TECHNICAL DRAINAGE STUDY RESPONSE TO COMMENTS

TROPICAL PKWY/CENTENNIAL PKWY ROADWAY IMPROVEMENTS

Re: **Technical Drainage Study for Tropical Pkwy./Centennial Pkwy. Roadway
Improvements
CNLV No. 43988**

The purpose of this letter is to address comments contained in the November 30, 2011 review memorandum prepared for the above referenced project. The comments are addressed as follows:

V:33.3333333

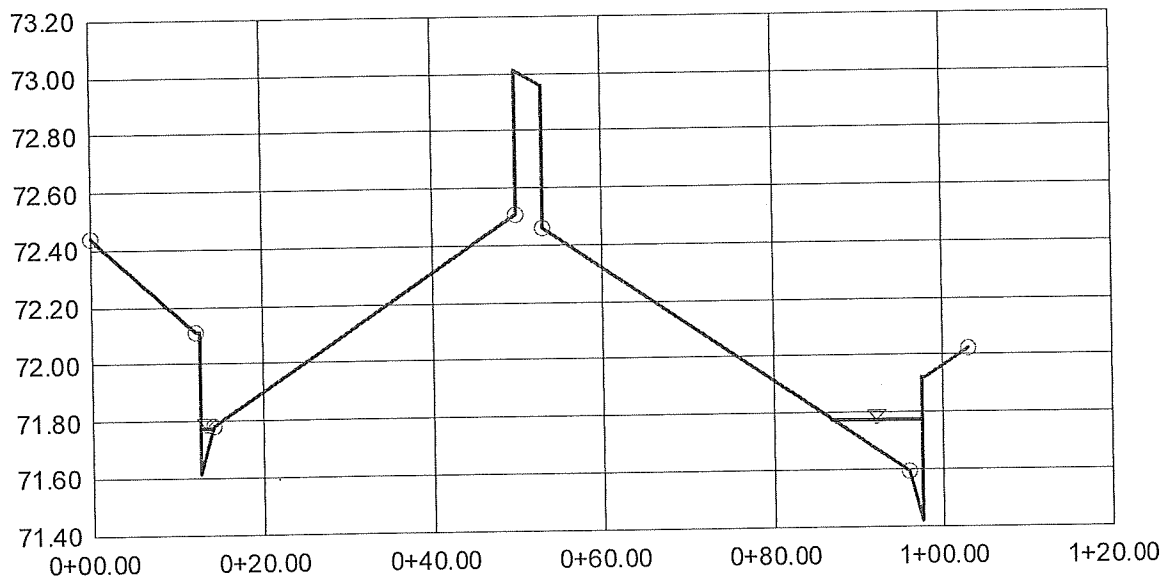
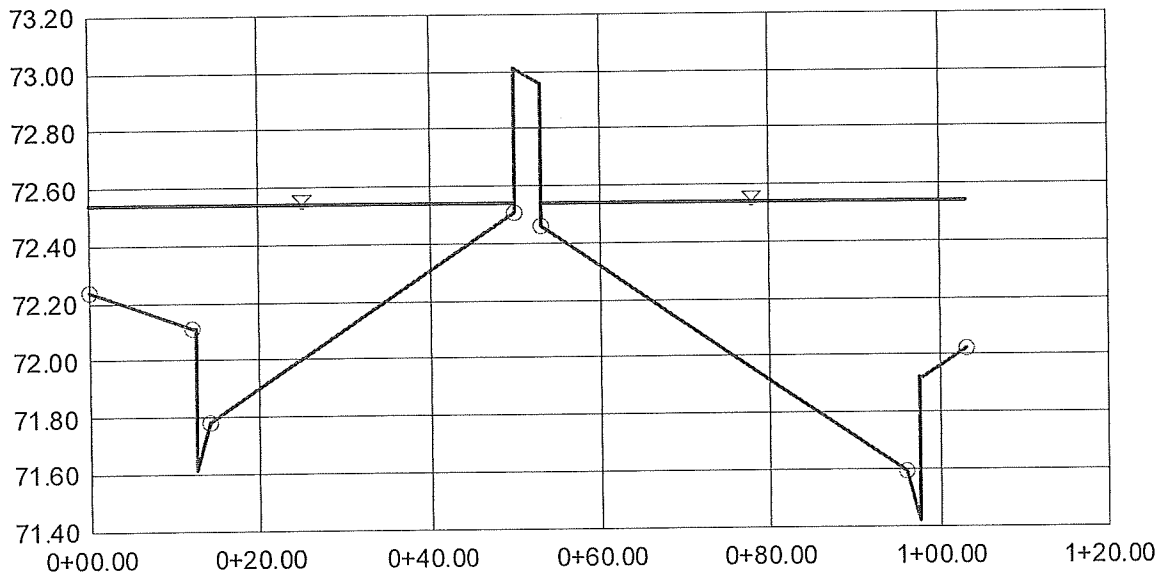
- 10. Comment:** Please revise the Flowmaster calculations for the interim and future conditions of Centennial Parkway and Tropical Parkway to show the proposed concrete median islands.

Response: Noted. Please refer to Appendix F for the revised worksheets. All street flow calculations have been revised to the current values. Street sections have been revised to include the center median.

DATE: 9/23/11
DRAFTER: RFF
DESIGNER: RFF
CHECKED: RFF
PROJECT NO.
MGL1101.000
EXHIBIT F
SHEET 2 OF 3

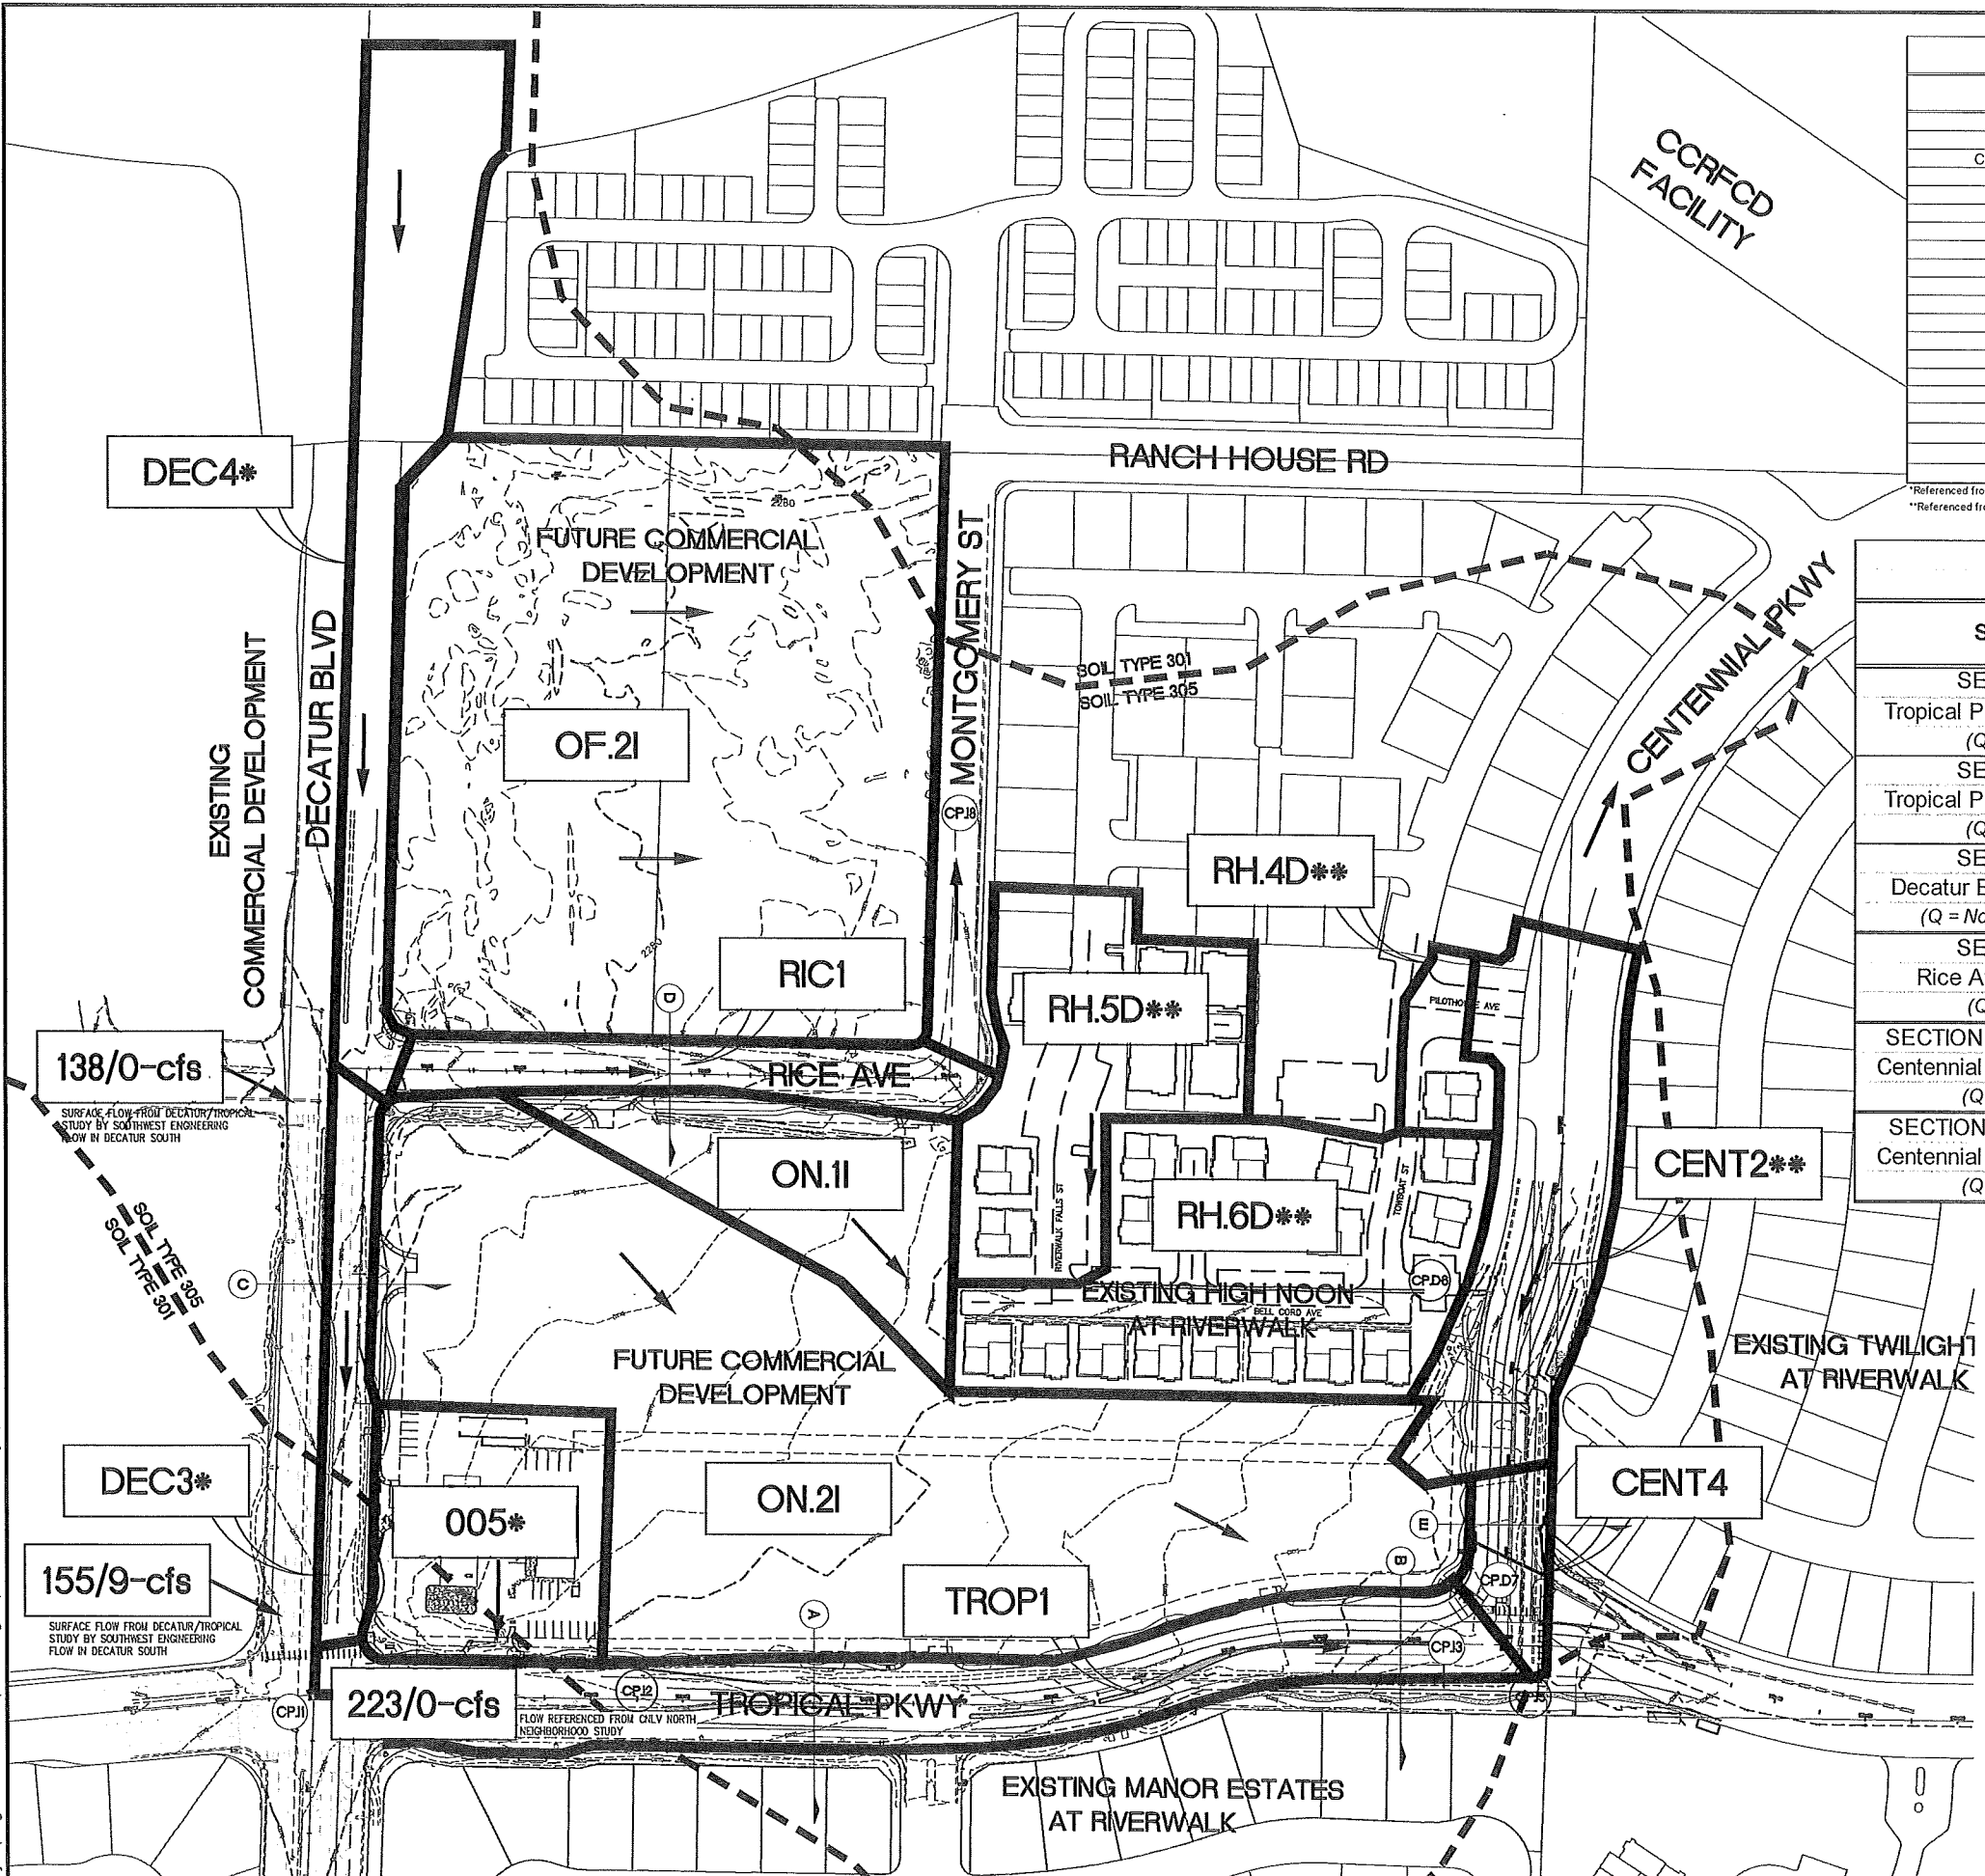
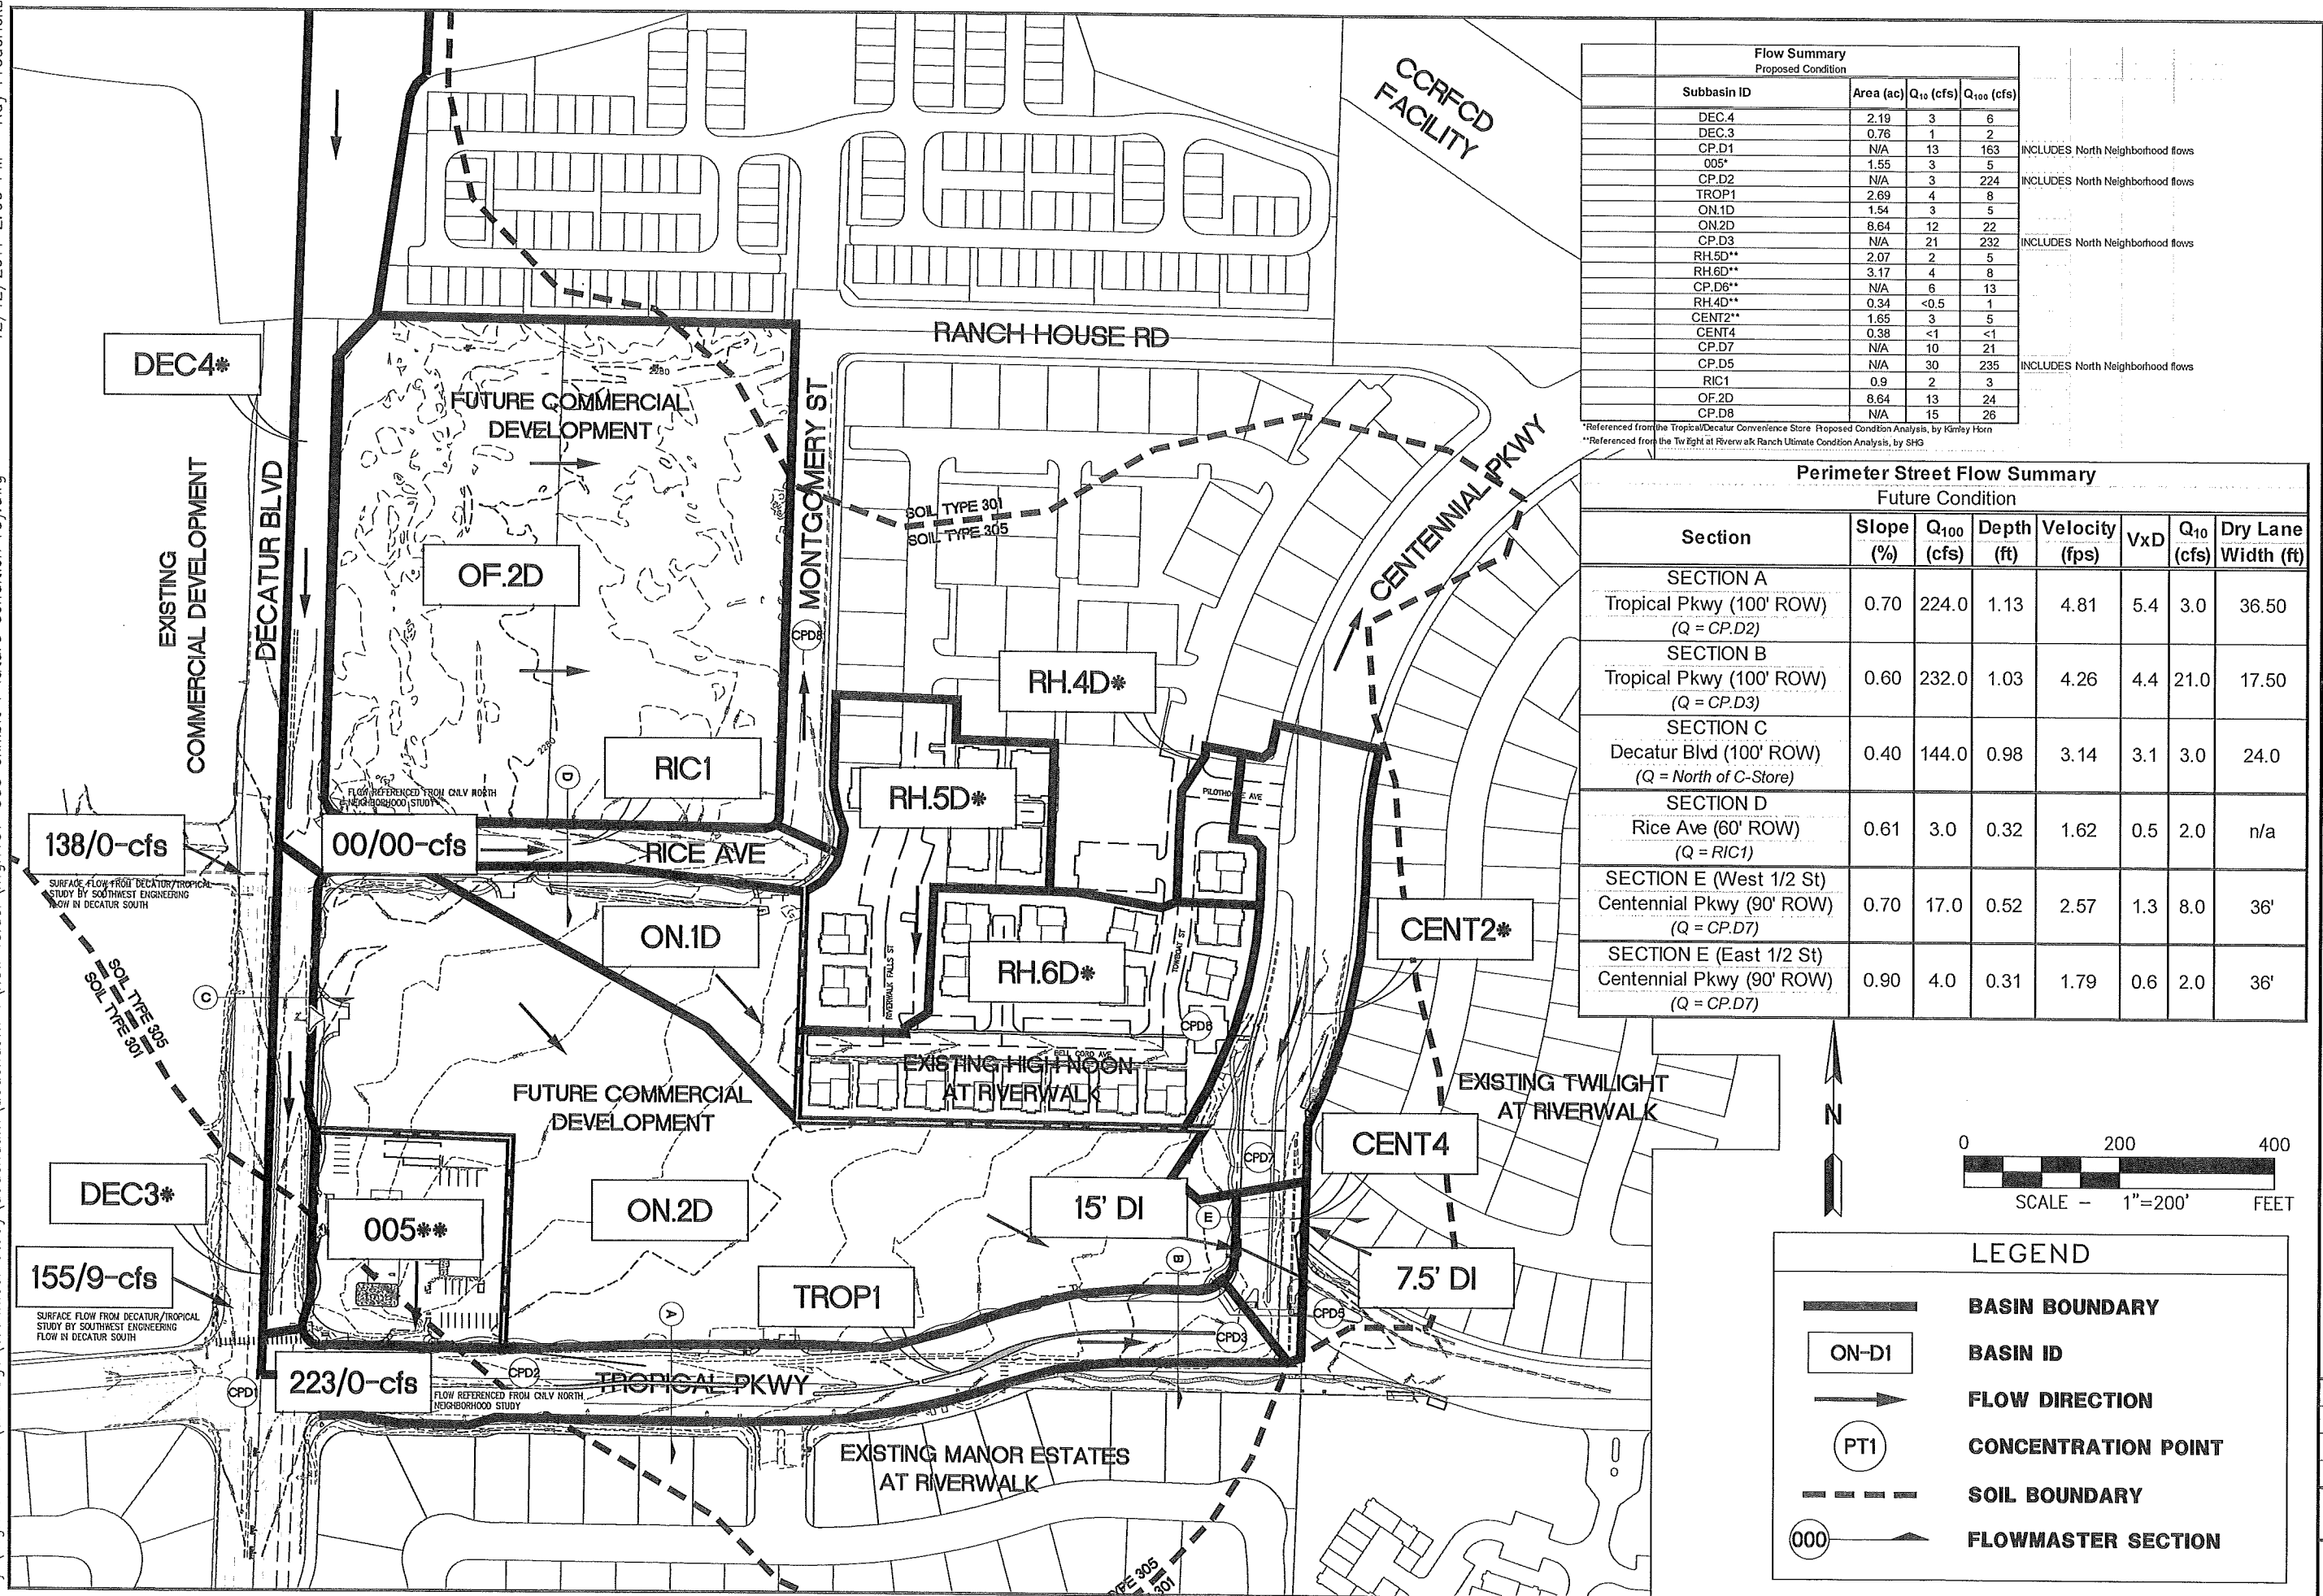
7. **Comment:** *Please explain and demonstrate how the Q_{approaching}=26 cfs in Table 8 of the TDS was obtained. The Interim and Future Condition Basin Maps show that Q₁₀₀=21 cfs instead of Q₁₀₀=26 cfs at Section E-E.*

Also, it appears that a portion of the Q₁₀₀=302 cfs and Q₁₀=78 cfs from Tropical Parkway will turn north adding to the flows in Centennial Parkway at the proposed drop inlets. Please evaluate and perform the necessary flow split calculations and revise all street and drop inlet capacity calculations to reflect the revision as necessary.

Response: Please refer to the grading plans enclosed with this submittal. The grading concept for this intersection has been revised. The grading will no longer allow for storm water from Tropical Parkway to head north in Centennial Parkway. The drop inlets will remain to capture the 21 cfs conveyed south in Centennial Parkway. The west DI (15-ft) will capture the 17 cfs from the west half of the street while the 7.5-ft modified Type C will capture the 3/4 cfs from the east half of Centennial. Please see the drop inlet sizing calculations in Appendix F as well as the revised grading plans. No additional calculations are required.
